Technical Bulletin

Section Title: Engine
 TSB No. TS 34 04262

SUBJECT: SERVICE MANUAL UPDATE: TENSIONER AND IDLER PULLEY REMOVAL AND INSTALLATION
MODEL(S): GRAND VITARA (JB424)
YEAR: 2009~2011

Tensioner and Idler Pulley Removal and Installation

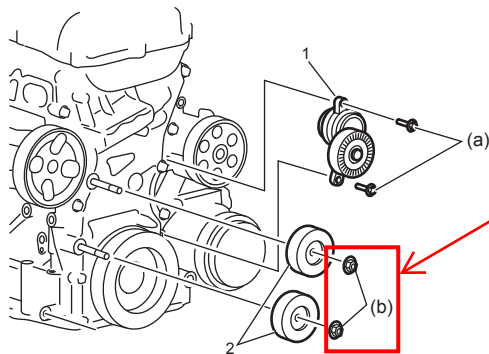
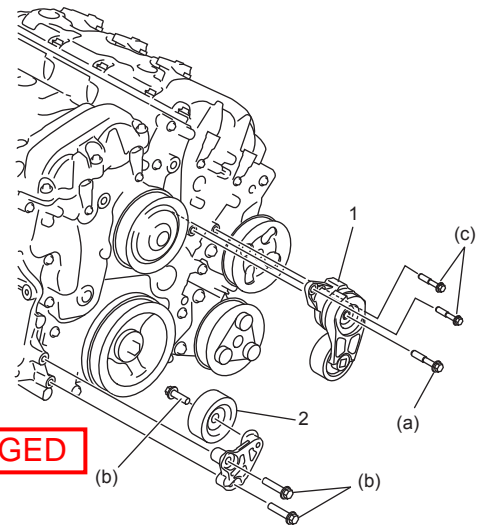
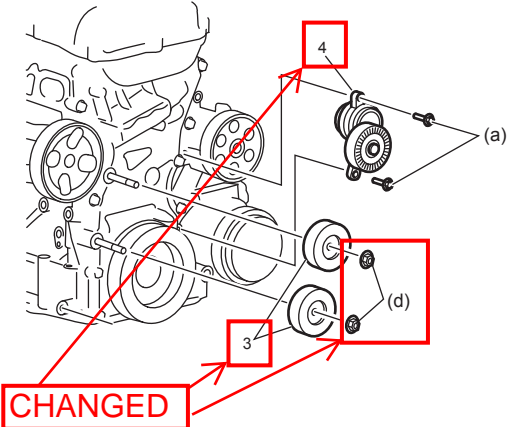
- Steps added to the tensioner and idler removal procedure for Removal of the Water Pump.
- The idler pulley fastener and the tightening torque have been changed as follows beginning with April 2009 production.

CHANGED

- 1) Remove accessory drive belt. (Accessory Drive Belt Removal and Installation)
- 2) For N32A, remove tensioner(1) and idler pulley(2).
- 3) For J24B, remove idler pulleys(3) and tensioner(4) as follows.
 - a) Drain coolant. (Cooling System Draining): J24B
 - b) Remove idler pulleys(3).
 - c) Remove water pump. (Water Pump Removal and Installation): J24B
 - d) Remove tensioner(4).

- Tighten tensioner bolts and idler pulley bolts and/or nuts to specified torque.

Idler pulley bolt (b): 55 N·m (5.6 kgf-m, 40.5 lbf-ft)

Idler pulley nut (d): 40 N·m (4.1 kgf-m, 29.5 lbf-ft)

- For N32A, tighten timing chain cover bolts to 20 N·m (2.0 kgf-m, 15.0 lbf-ft), and retighten them to 60 N·m (6.1 kgf-m, 44.5 lbf-ft).

Tensioner bolt (a): 25 N·m (2.5 kgf-m, 18.5 lbf-ft)

**Timing chain cover bolt * (c): 20 N·m → 60 N·m
(2.0 kgf-m → 6.1 kgf-m, 15.0 lbf-ft → 44.5 lbf-ft)**

Tensioner and Idler Pulley Removal and Installation

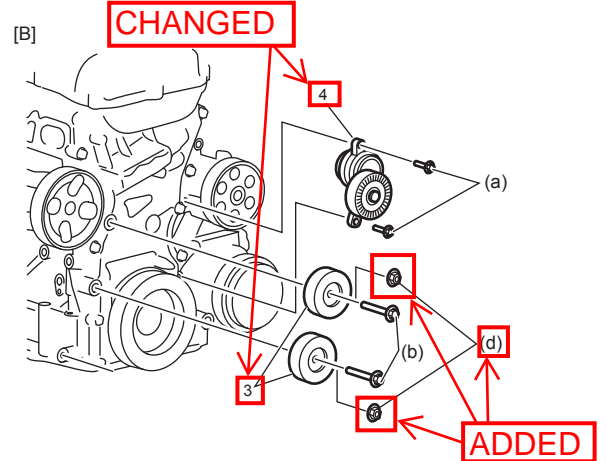
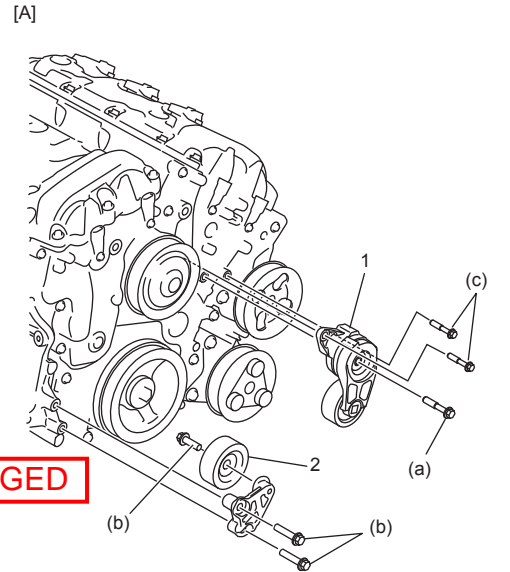
- 1) Remove accessory drive belt. (Accessory Drive Belt Removal and Installation)
- 2) For N32A, remove tensioner(1) and idler pulley(2).
- 3) For J24B, remove idler pulleys(3) and tensioner(4) as follows.
 - a) Drain coolant. (Cooling System Draining): J24B
 - b) Remove idler pulleys(3).
 - c) Remove water pump. (Water Pump Removal and Installation): J24B
 - d) Remove tensioner(4).

- Tighten tensioner bolts and idler pulley bolts and/or nuts to specified torque.

Idler pulley bolt (b): 55 N·m (5.6 kgf-m, 40.5 lbf-ft)

Idler pulley nut (d): 40 N·m (4.1 kgf-m, 29.5 lbf-ft)

Timing chain cover bolt * (c): 20 N·m → 60 N·m
(2.0 kgf-m → 6.1 kgf-m, 15.0 lbf-ft → 44.5 lbf-ft)
